Access Compliance Report Public Rights-of-Way (Curb Ramps)

Main Street: NEWPORT_AVE		Cross Street: TROPIC_LN		Location:	E
ADA ID: RPRK220126110249	Ramp Type: Type 4 - Parallel	Initial Pass/Fail: Fail	Overall Compliance: No	Severity Score:	2
Codes/Mitigation Info/Possible Solution			Field Measurements/Component Compliance

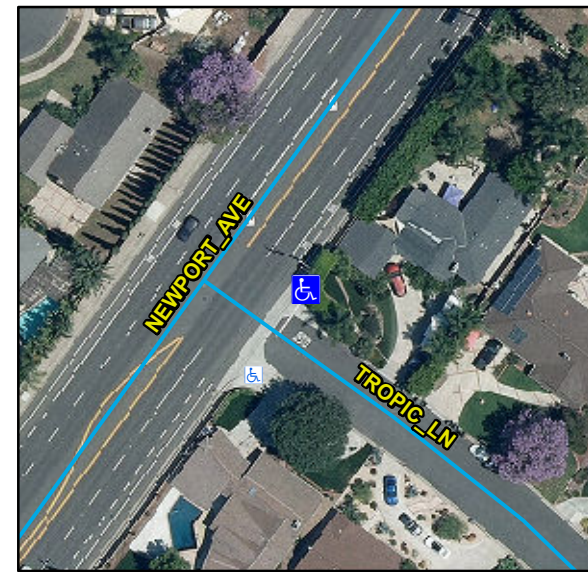
Compliance	Description	Data	Compliance	Description	Data
N/A	Ramp Length LT (in)	104	N/A	Ramp Length RT (in)	83
Yes	Ramp Width LT (in)	87	Yes	Ramp Width RT (in)	87
Yes	Ramp Run Slope LT (%)	6	Yes	Ramp Run Slope RT (%)	1.5
Yes	Ramp Cross Slope LT (%)	1.9	No	Ramp Cross Slope RT (%)	2.4
N/A	Landing Present	N/A	N/A	DWS Provided	N/A
N/A	Landing Length (in)	N/A	N/A	DWS Contrast	N/A
N/A	Landing Width (in)	N/A	N/A	DWS Length (in)	N/A
N/A	Landing Run Slope (%)	N/A	N/A	DWS Full Width	N/A
N/A	Landing Cross Slope (%)	N/A		DWS Offset Type	N/A
N/A	Landing Movement Obstructed?	N/A	N/A	DWS Offset Left (in)	N/A
	Landing Movement Type	N/A	N/A	DWS Offset Right (in)	N/A
N/A	Landing Shared	N/A			
N/A	Clear Space	Yes			
N/A	Clear Space To Crosswalk (in)	N/A			
N/A	Marked Crosswalk 1	No	N/A	Marked Crosswalk 2	No
	Crossing 1 Direction	NW		Crossing 2 Direction	SW
	Marked Crosswalk 1 Width (in)	N/A		Marked Crosswalk 2 Width (in)	N/A

N/A	Ramp Inside Crosswalk 1	N/A	N/A	Ramp Inside Crosswalk 2	N/A
	Crossing 1 Slope (%)	7.2		Crossing 2 Slope (%)	3.1
	Crossing 1 Cross Slope (%)	2.8		Crossing 2 Cross Slope (%)	1.5
N/A	Gutter Ponding	N/A	Yes	Curb Slope	3.1
Yes	Gutter Lip Height (in)	0		Road Run Slope (%)	0.4
N/A	Gutter Run Slope (%)	N/A		Road Cross Slope (%)	2.3
N/A	Gutter Cross Slope (%)	N/A	Yes	Perpendicular Joint Present	Yes
Yes	Overall Surface Condition	Acceptable			
	Cross Gutter Present?	Yes		Spandrel Present?	Yes
	Replace Cross Gutter?	No		Replace Spandrel?	No

Remove & Replace Curb Ramp With Two New Directional Ramps or Equivalent.

R304.5.3, STD 1115
